**EVERLIGHT Electronics Co., Ltd.**

**PCN tracking number: PCN20250926-02 - CN25090006****DATE: 09/09/2025****Contact:****Title:** PM**E-mail:** \_\_\_\_\_**Phone:****Fax:** + \_\_\_\_\_Product influenced:  Major change  Minor change

# Lamp 支架變更說明（PIN腳霧錫）

Lamp Support Change Description (PIN PIN tin)

# 說明/Purpose of Change

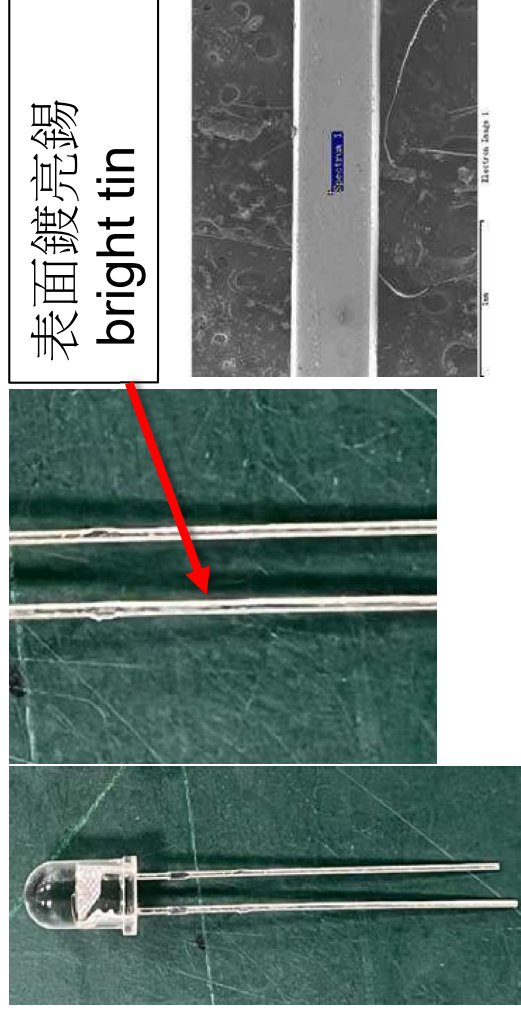
- 委外電鍍製程（亮錫）：因支架外面有氧化層，電鍍時需先退氧化層後再鍍錫，當支架氧化程度不一時，電鍍去除氧化層穩定性不佳，會有脫錫風險；  
來料電鍍製程（霧錫）：來料鍍錫支架，支架電鍍穩定性和結合性佳，不需退氧化層再重鍍，故不會出現脫錫風險

The current tin plating process requires a de-oxidation process before the plating, which has the possibility to cause low solder-ability if insufficient de-oxidation, or cause lead-frame damage if excess de-oxidation. Whereas using use silver plate (Ag) lead-frame provided from the supplier will not have this problem

# 支架外觀/鍍層結構

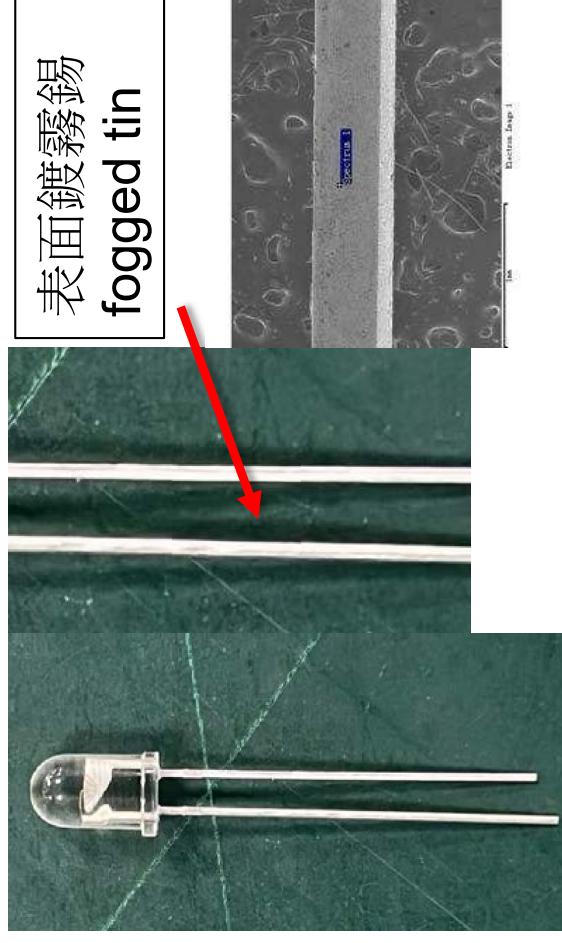
委外鍍錫 ( PIN腳鍍亮錫 )

PIN with bright tin

成品：鐵 + 亮錫

來料鍍錫 ( PIN腳鍍霧錫 )

PIN with fogged tin

成品：鐵 + 霧錫

成品僅PIN腳表面鍍層由亮錫改為霧錫，其他尺寸不做變更

Only the surface coating of PIN foot is changed from bright tin to mist tin, and other dimensions are not changed
